**FINDINGS AND RECOMMENDATION
OFFICE OF PLANNING AND ZONING
ANNE ARUNDEL COUNTY, MARYLAND**

CASE NUMBER: 2023-0142-V

REQUEST

The applicants are requesting a variance to allow a dwelling addition (deck) with less setbacks than required and that does not comply with the designated location of a principal structure on a waterfront lot on property located at 7750 Rockanna Road in Pasadena.

LOT 8
 'ROCKANNA'
 PB 23-4

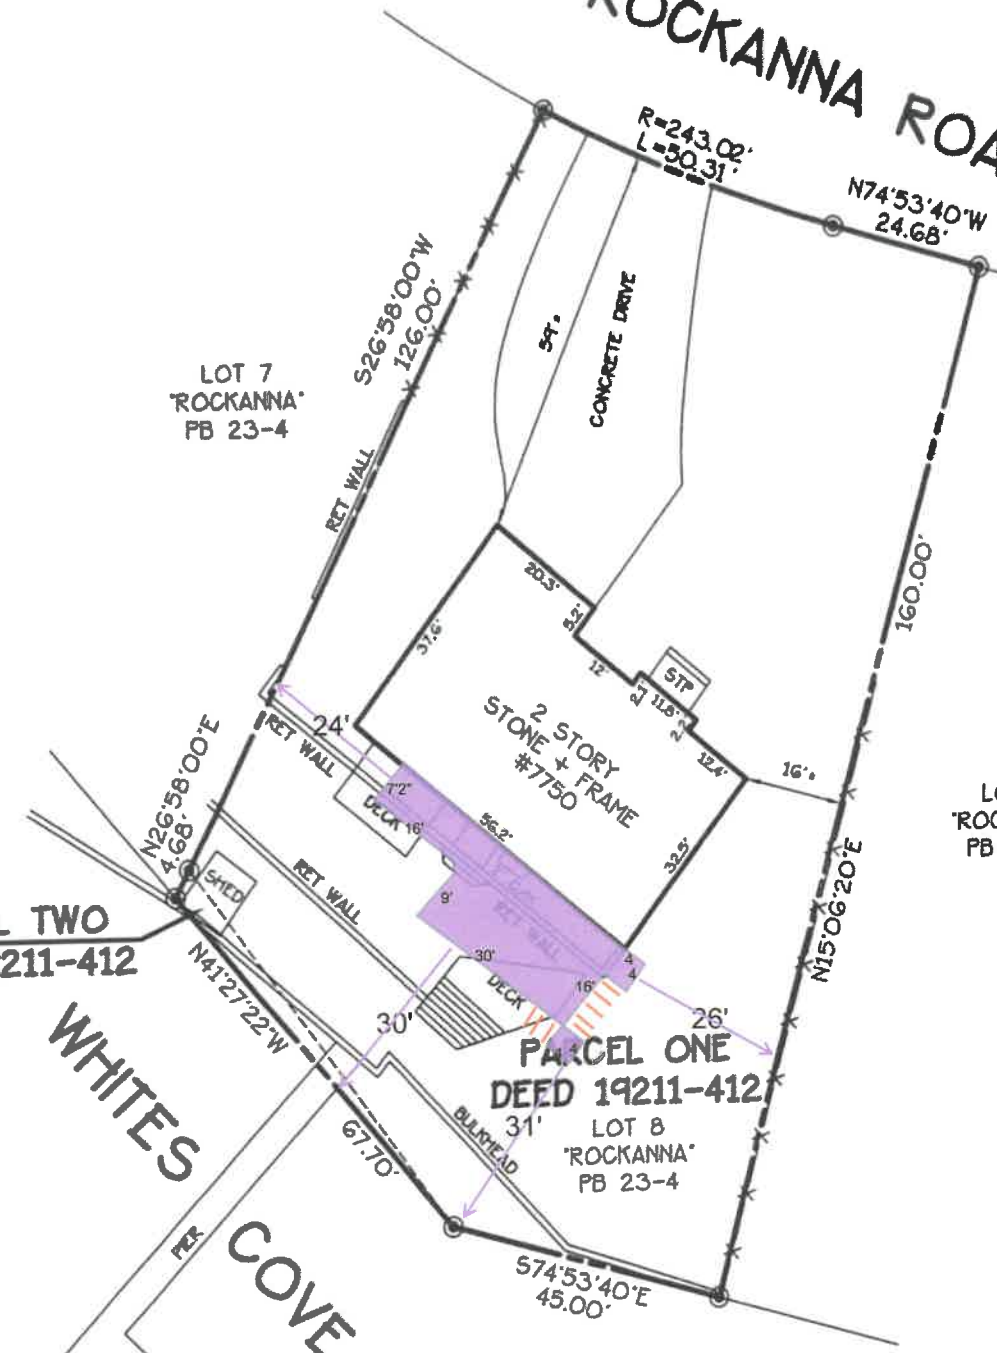
The **Critical Area Team** comments that the existing deck needs to be repaired/replaced but there is no justification provided for an expansion. The existing home is substantially further forward than the adjacent homes and additional encroachment is not warranted.

The applicants are proposing a deck which is much larger than the existing deck. As a result, the proposed deck and steps to grade project closer to the shoreline than the existing deck and may impair the view of the neighbor to the east. Shifting the deck due to the location of the septic system is justified, however, justification as to why the deck needs to project closer to the shoreline, on a house that is already closer than its neighbors, was not provided. Nor have the applicants provided justification as to why the proposed deck and steps must span past the eastern edge of the house. Reducing the depth and width of the proposed deck would reduce any view obstruction to the neighbor to the east.

While decks are common additions to single family dwellings, including along the waterfront side of waterfront dwellings, the proposed deck is simply too large given the context, and should be reduced. Because there is opportunity to redesign the proposed deck and steps to grade, and because there is not sufficient justification, the variance request cannot be considered the minimum necessary to afford relief.

Based upon the standards set forth in § 18-16-305 of the Code under which a variance may be granted, this Office recommends *denial* of a zoning variance to § 18-2-402(1) to allow a dwelling addition that does not comply with the designated location of a principal structure.
